**DESIGN/DEVELOPMENT REVIEW COMMISSION
DESIGN REVIEW DISTRICT
HISTORIC AGENDA
EVALUATION SHEET
Case #12**

ADDRESS: NX2210 Wayne Street (Project 2)

NATURE OF REQUEST: Request for a Certificate of Design Approval for
new construction

Front Elevation
Option #2

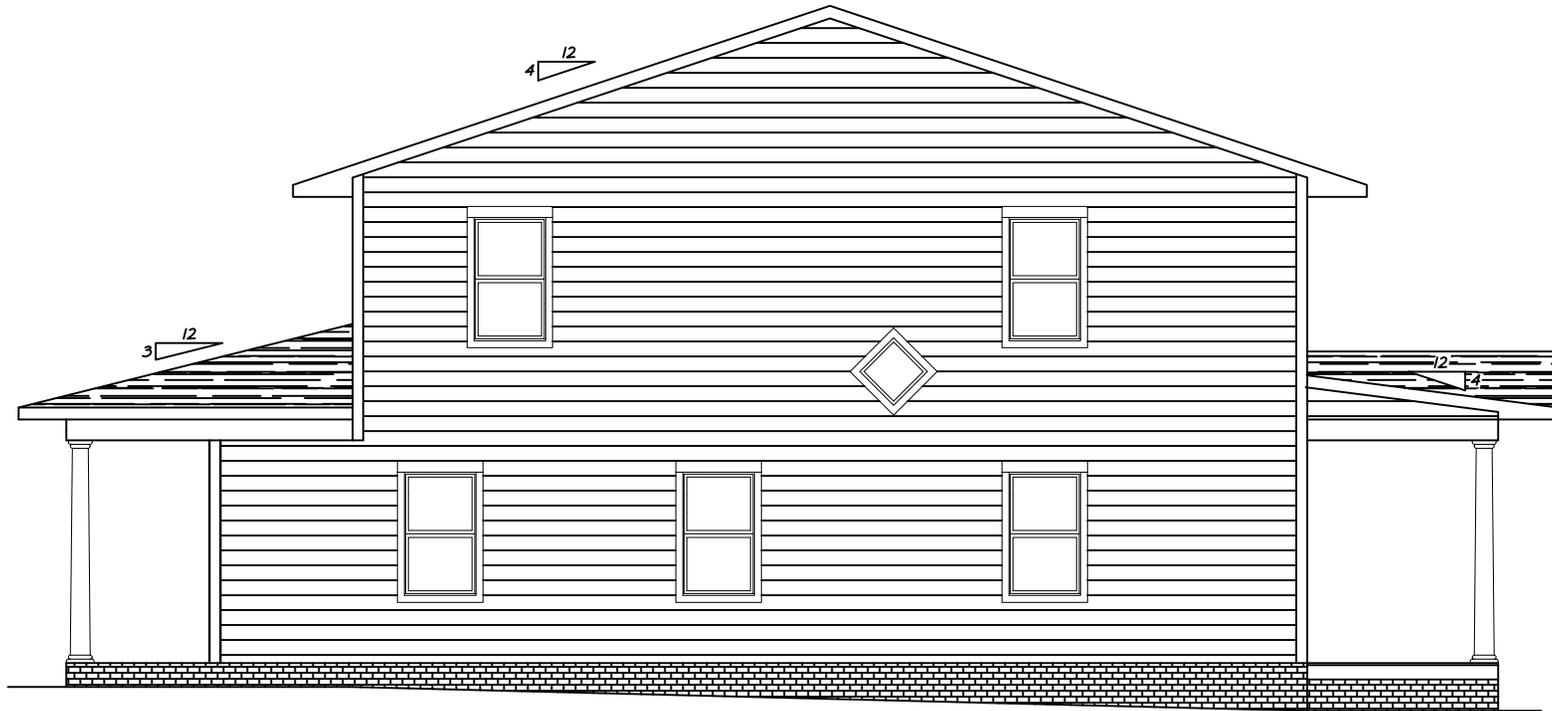
The proposed house features a 1-story full-façade shed roof porch with a central pedimented gable. The porch is supported by smooth round Tuscan columns. The shed roof design is not consistent with other houses on the block or street, which typically have half-hip front porches. Staff recommends changing the shed roof portion of the porch to a half-hip design to be more compatible with surrounding structures.

The front elevation shows a 4/12 pitch for the primary roof, which is not consistent with surrounding buildings or the architectural style of the house. Side gabled houses in this style typically have rectangular footprints that are wider than they are deep. Staff recommends increasing the roof pitch to somewhere in the 6/12 to 8/12 range as it is more visually compatible with other historic roof pitches found within the district. This may require changing the footprint of the house to a more rectangular plan with a longer 1-story portion on the rear of the building. For reference, other side gabled houses in the district have roof pitches that appear to be between 8/12 and 10/12. All roofing surfaces will feature 30-year architectural shingles.

Shutters: The applicant is proposing board and batten shutters for the windows on the primary façade. Staff recommends using louvered, flat-panel, or raised-panel shutters to be more consistent with the district as well as the style of the house. Shutters should be sized appropriately to fit the windows and feature hardware (hinges, shutter dogs, etc.) that makes them functional or appear to be functional.

Door: The proposed front door design features a rectangular upper glass insert over two vertical raised panels. The architectural style of the house has more in common with Colonial Revival style houses in the district; therefore, staff recommends a six-panel colonial door instead of the proposed Craftsman style door. The door will be constructed of insulated fiberglass and/or wood.

- The primary roof pitch shall be increased to the 6/12 to 8/12 range
- The shed roof portion of the front porch shall be changed to a half-hip design to be more compatible with surrounding structures
- Windows shall be wood or aluminum-clad
- Windows on the first and second floors near the rear of the house on both sides shall be vertically aligned
- Appropriately sized louvered, flat-panel, or raised-panel shutters shall be installed on the primary façade with hardware (hinges, shutter dogs, etc.) that makes them functional or appear to be functional
- A insulated fiberglass and/or wood six-panel Colonial door shall be installed
- The foundation for the house and porch shall be clad in brick veneer
- Setback of the house shall be flush with existing adjacent houses
- All details deferred to staff.

Lt. Side Elevation
Option #2

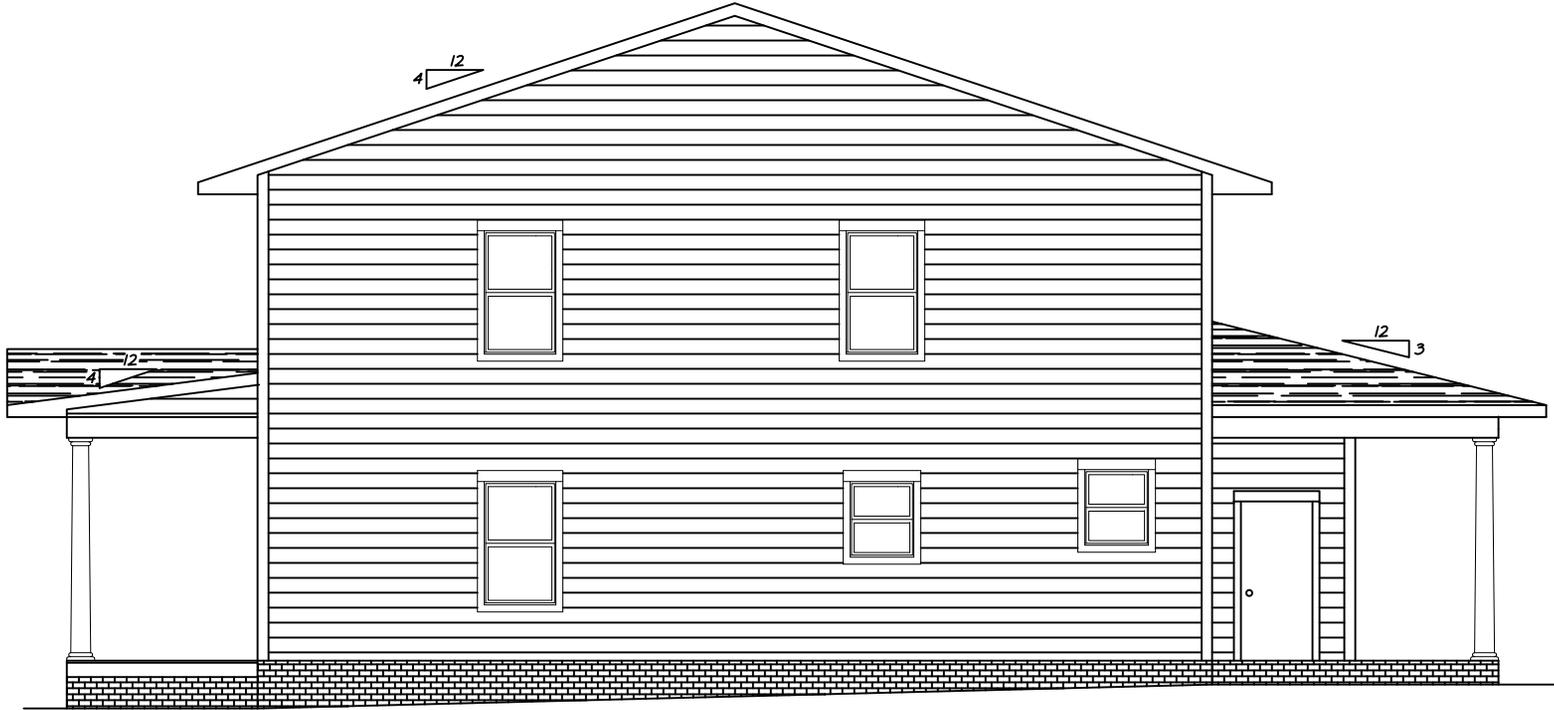
The massing of the proposed house is generally compatible with existing historic buildings on the block or street. The fenestration pattern is balanced and generally consistent with other configurations found within the district. Staff recommends vertically aligning (stacking) the windows on the first and second floors near the rear of the house on both sides to be more in keeping with historic patterns found in the district.
